| Notice of Allowability | Application No. | Applicant(s) | |
| | 10/633,296 | CZYSZ, MICHAEL | |

EXAMINER'S AMENDMENT

Fig. 4

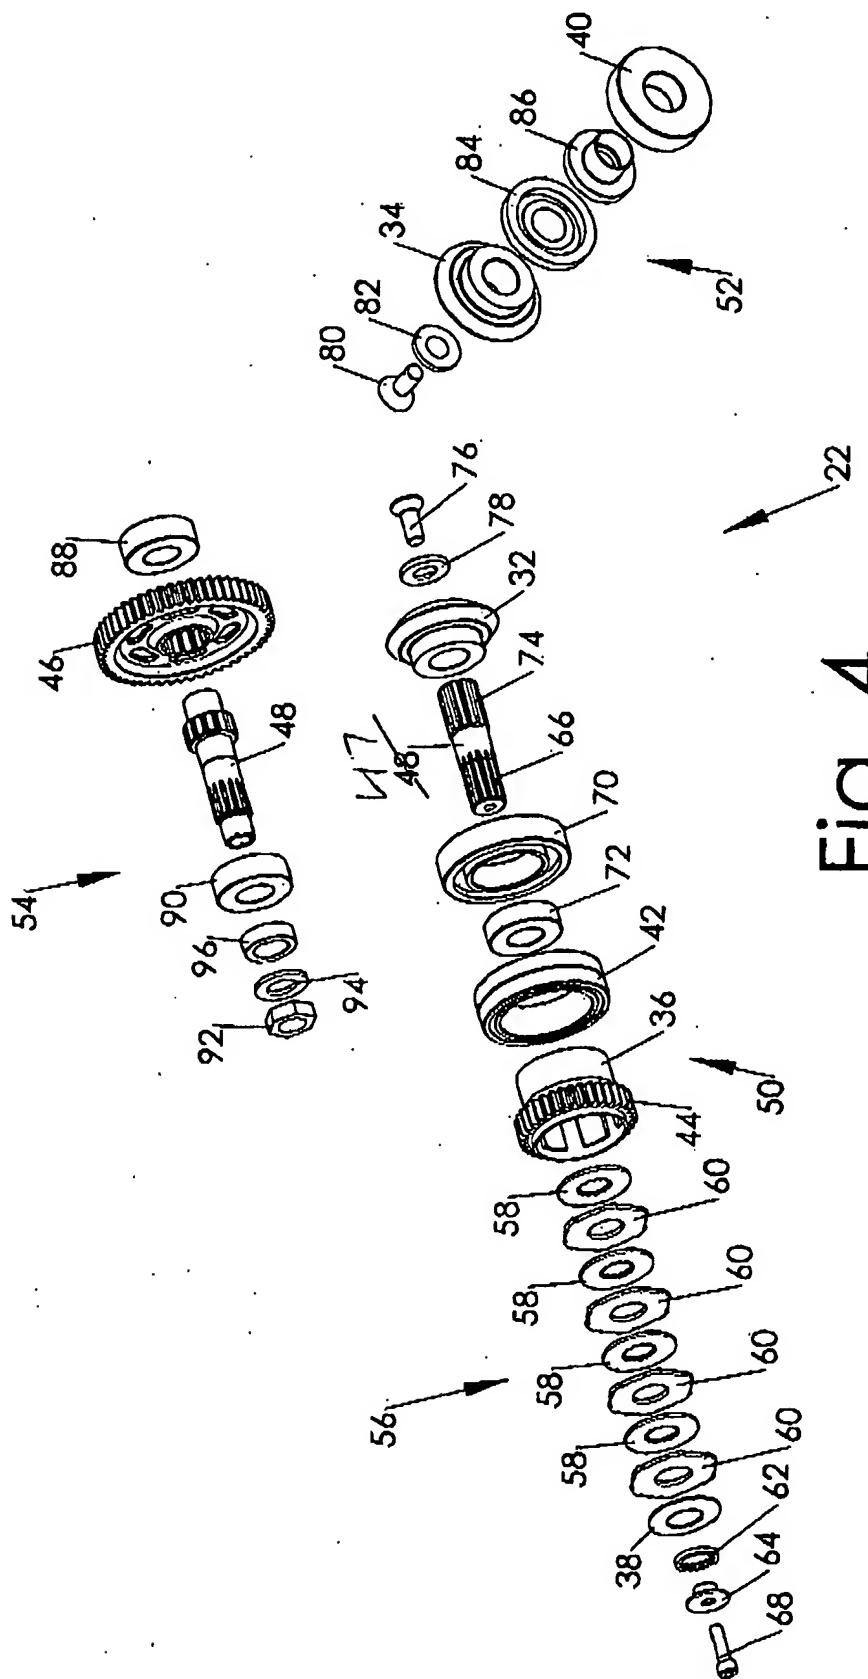
The following changes to the drawings have been approved by the examiner and agreed upon by applicant: Fig. 4 has been amended to change an occurrence of reference numeral "48" to -47—(see enclosure). In order to avoid abandonment of the application, applicant must make these agreed upon drawing changes.
